**TO:** Dr. Jesse Bacon, Superintendent *JTB*  
**FROM:** Danny Clemens, Director of Facilities  
**Date:** May 8, 2024  
**RE:** Bernheim - Change Order 12 - Added Admin Refrigerators **DC**

# Change Order Request 17 - PCO #51 - RFP-13 Refrigerator Locations

# REQUEST FOR PROPOSAL

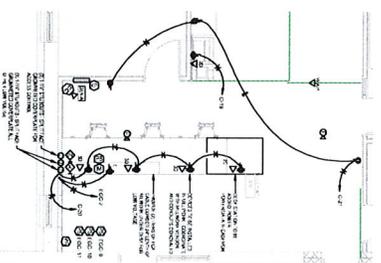
- Item 1:** REFERENCE A5.6
- Extend the countertop along the plan north wall in the Health Room A104
  - Remove the upper wall cabinet, the lower base cabinet and modify the countertop in Corridor A110A to accommodate a full-size refrigerator.
- Item 2:** REFERENCE E4.1
- Refer to corridor A110A. Revise outlet for circuit C-29 to 4'-0" – no counter. Revise breaker to GFCI.
  - Refer to corridor A110A. Add additional above counter outlet for alcove with 20A circuit C-43
  - Refer to health A104. Revise em outlet to a dedicated 20A circuit EGC-15.
- Item 3:** REFERENCE E7.1
- Refer to updated panel schedule "C".
- Item 4:** REFERENCE E7.3
- Refer to updated panel schedule "EGC".

<b>Creator</b>	Keith Joseph (Kentuckiana Electrical Services)	<b>Total cost</b>	1,771.52 USD
<b>Assignee</b>	Keith Joseph (Kentuckiana Electrical Services)	<b>Reason</b>	Design change
<b>Status</b>	Pending approval	<b>Reference number</b>	—
<b>Due date</b>	—	<b>Schedule impact?</b>	No
<b>Description</b>	Per RFP-13 Add Duplex Outlet and GFCI Breaker
